**BOARD OF ZONING ADJUSTMENT
STAFF REPORT****Date: September 10, 2018****CASE NUMBER**

6191

SWIMMING POOL SETBACK VARIANCE: To allow a 6'-deep swimming pool to be constructed 5.5' from a rear property line in an R-1, Single-Family Residential District.

SITE PLAN

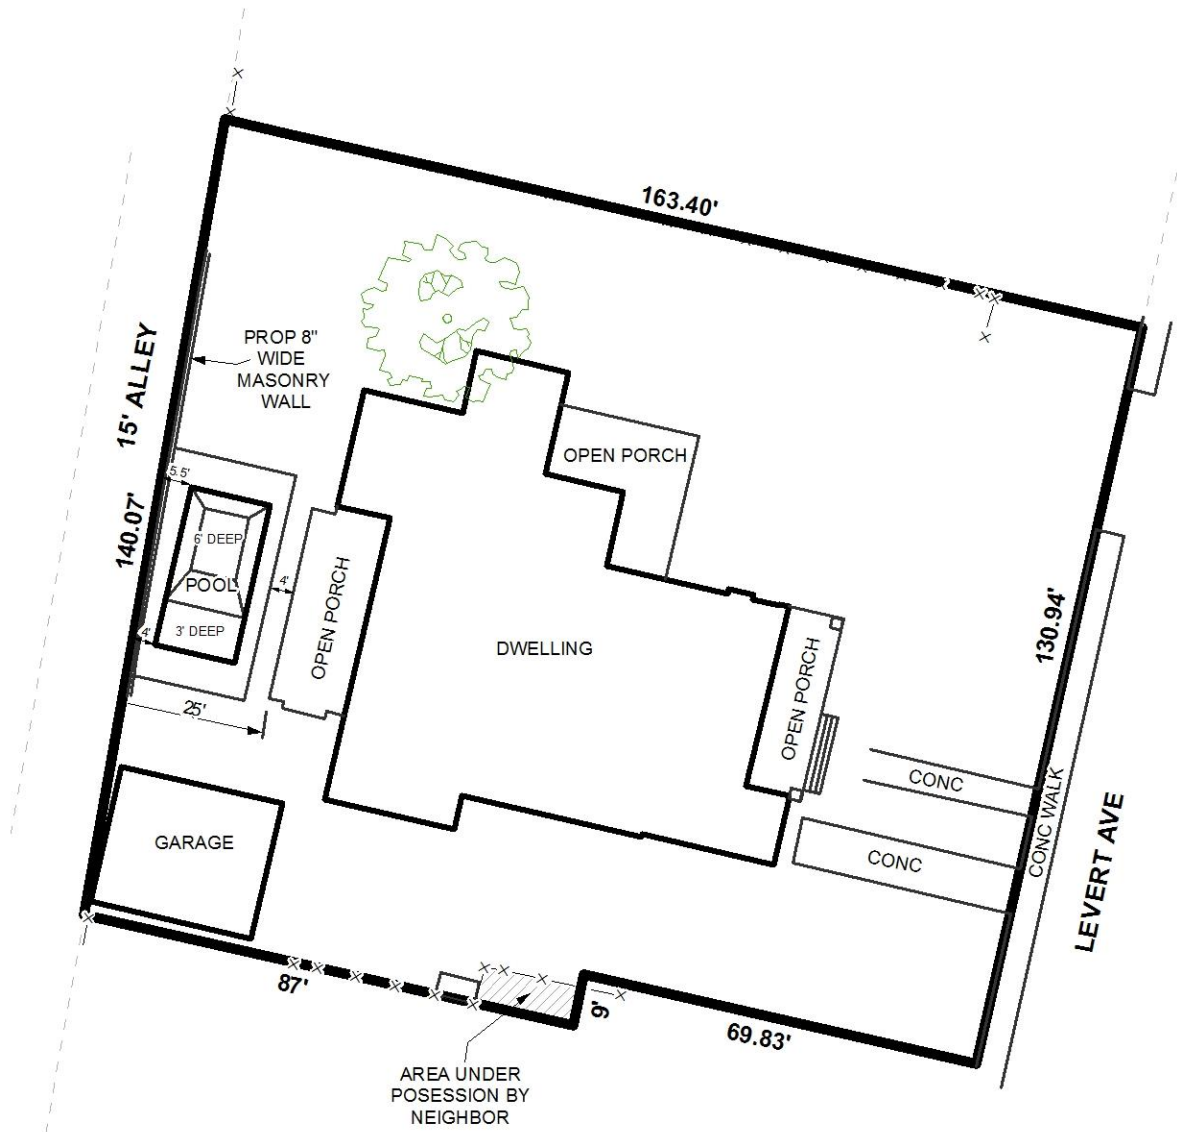
Section 64-4.D.12.a. of the Zoning Ordinance requires a swimming pool to be located from any side or rear property line a distance equal to at least one (1) foot greater than the maximum depth of the swimming pool. The site plan illustrates a proposed pool 5.5' from the rear property line of the subject site. The maximum depth of the proposed pool is six (6) feet, thus the pool, and the area around the pool, is required to be set back a minimum of seven (7) feet from the rear property line.

Regarding the applicant's wish to preserve the existing 36" cedar tree as justification for the request, staff cannot substantiate that a pool with a compliant setback would be detrimental to the tree's root system. Staff is aware that there may be limitations on where the pool may be placed with regards to the size of the subject site's rear yard, thus suggesting a possible hardship; however, the applicant has not presented evidence that a smaller or redesigned pool could not meet the requirements of the Zoning Ordinance while also maintaining the existing tree's roots. The applicant, instead, simply wishes to have a pool constructed too close to the property line.

RECOMMENDATION: Based on the preceding, staff recommends to the Board the following findings of fact for Denial:

- 1) Granting the Variance will be contrary to the public interest in that it will be contrary to Section 64-4.D.12.a. of the Zoning Ordinance regarding swimming pool setbacks in an R-1, Single-Family Residential District;

- 2) Special conditions may exist, such as a rear yard with minimal space in which to construct a pool, but not in such a way that a literal enforcement of the provisions of the chapter will result in an unnecessary hardship since a smaller or redesigned pool could meet the requirements of the Zoning Ordinance while preserving the cedar tree; and,

"A"

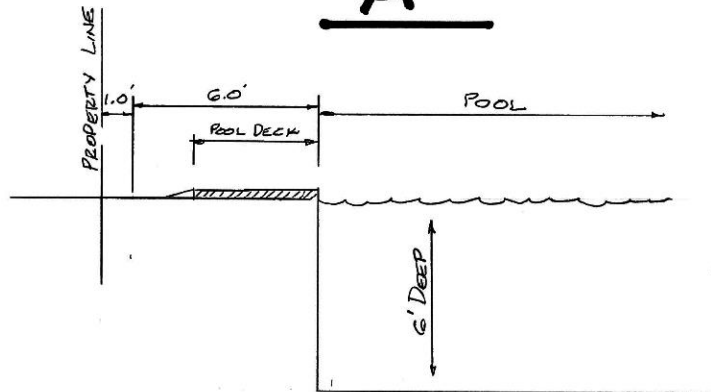
THE OWNERS DO NOT WANT TO REMOVE OR DISTURB THE ROOT SYSTEM OF THE 36" CEDAR TREE ON THE NORTH SIDE OF THE DWELLING OR THAT AREA COULD BE CONSIDERED FOR THE POOL. DIAGRAM "A" ON ATTACHMENT ILLUSTRATES THE CITY CODE FOR A 6.0' DEEP POOL. DIAGRAM "B" ILLUSTRATES THE LOCATION OF THE POOL IN THIS VARIANCE REQUEST.
